UNITED STATES PATENT AND TRADEMARK OFFICE

APPLICATION NO.	FILING DATE	FIRST NAMED INVENTOR	ATTORNEY DOCKET NO.	CONFIRMATION NO.
10/539,665	06/14/2005	Sheng-Gen Pan	119065-032	4699
29177	7590	08/03/2009	EXAMINER	
K&L Gates LLP P.O. BOX 1135 CHICAGO, IL 60690			DUONG, DIEU HIEN	
ART UNIT	PAPER NUMBER			
	2821			
MAIL DATE	DELIVERY MODE			
08/03/2009	PAPER

DETAILED ACTION

Fig. 1

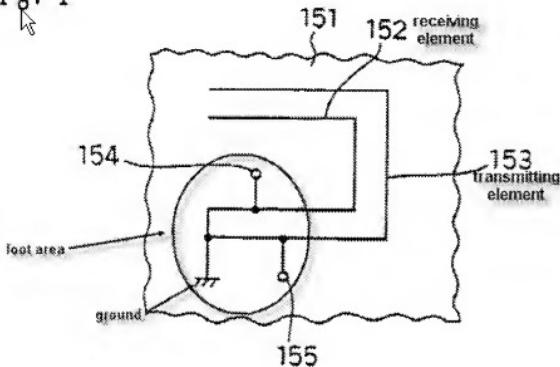
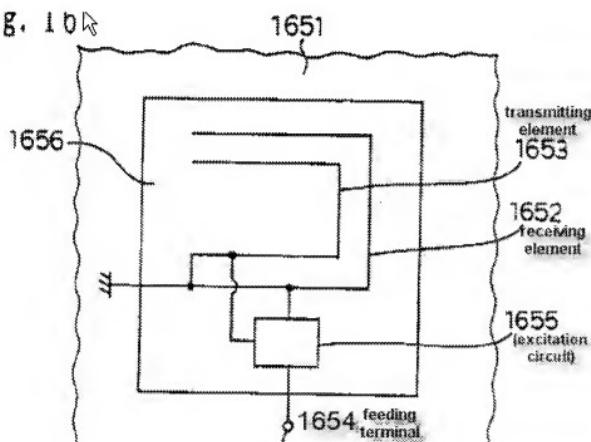
Regarding claim 6, Kane discloses, in Figures 1 and 16, an antenna structure having a substantially flat form with a ground connection, which is designed for use for at least two frequency bands, comprising

two transmitter/receiver antenna branches (152, 153), which are electrically conductively connected to a foot area, wherein the foot area surrounds the ground connection;

two RF supply connections (154, 155) that are arranged at a distance from one another, provided in the foot area, between which the ground connection is provided,

wherein the two transmitter/receiver antenna branches (152, 153) of the antenna structure are designed such that the two transmitter/receiver antenna branches are associated overlapping frequency bands; and

an excitation circuit with an RF supply line, which branches to the two RF supply connections.

Kane does not disclose wherein the frequency bands are overlapping. However, such difference is not patentable merits since it would have been obvious to one having ordinary skill in the art at the time the invention was made to set the lengths of the antenna branches to achieve desired frequency bands based on particular application or environment of use. Therefore, to employ having the frequency bands as claimed invention would have deemed obvious to person skill in the art of antenna.
